N1076A-01

Information Only Service Note

N1076A 32 GBd Electrical Clock Recovery

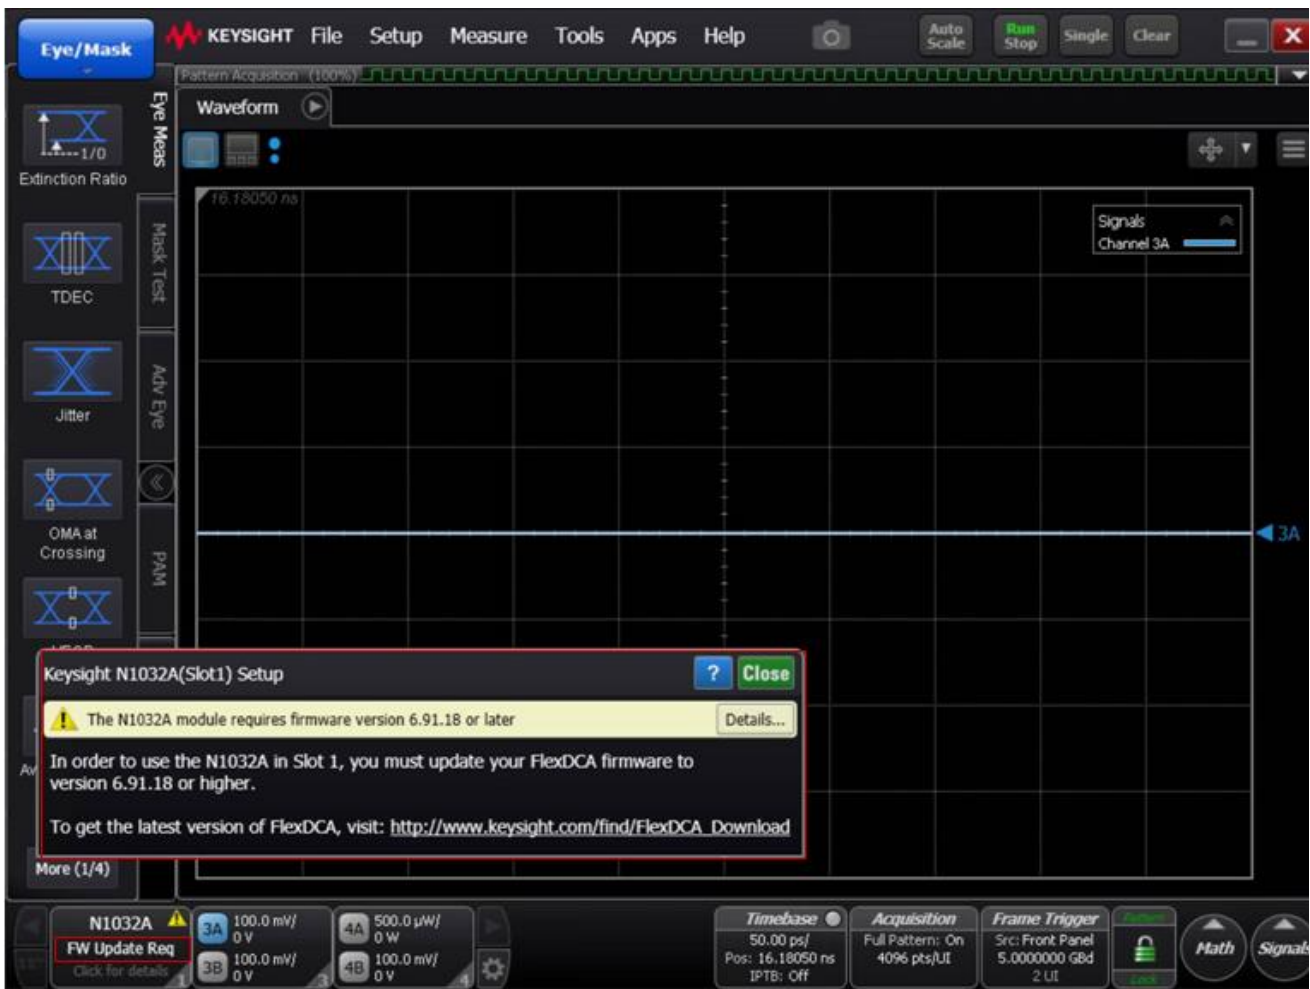
With the instrument connected to FlexDCA, if a message like the one below is displayed, FlexDCA must be updated to the indicated version (or later):

To update FlexDCA software, download from www.keysight.com/find/flexdca_download and install. While only the indicated version is required, updating to the latest version is recommended.
